6613C-07A

S E R V I C E N O T E

Agilent 6613C DC Power Supply

On faster computers, when programming over GPIB, a random error will occur.

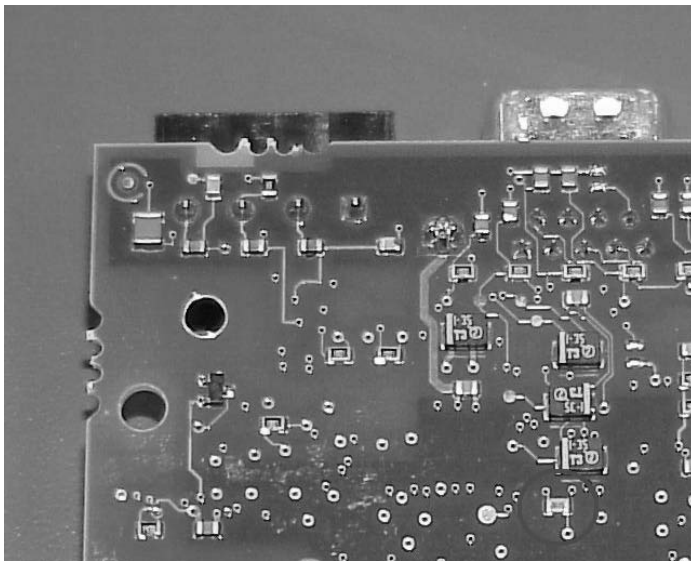
When programming a unit over GPIB, a random error -113 (“Undefined header”) will appear on the unit. This error can be read back via the front panel or over the GPIB bus.

Change resistor R1246 (see picture for location) from 511 Ohms to 100 Ohms (part number 0699-3058). This requires un-soldering and soldering a surface mount component and can be very difficult. This does not require re-calibration.

Replace the entire GPIB assembly (part number 5063-4841) with a newer one that has the 100 Ohm resistor. This will require the unit to be re-calibrated.
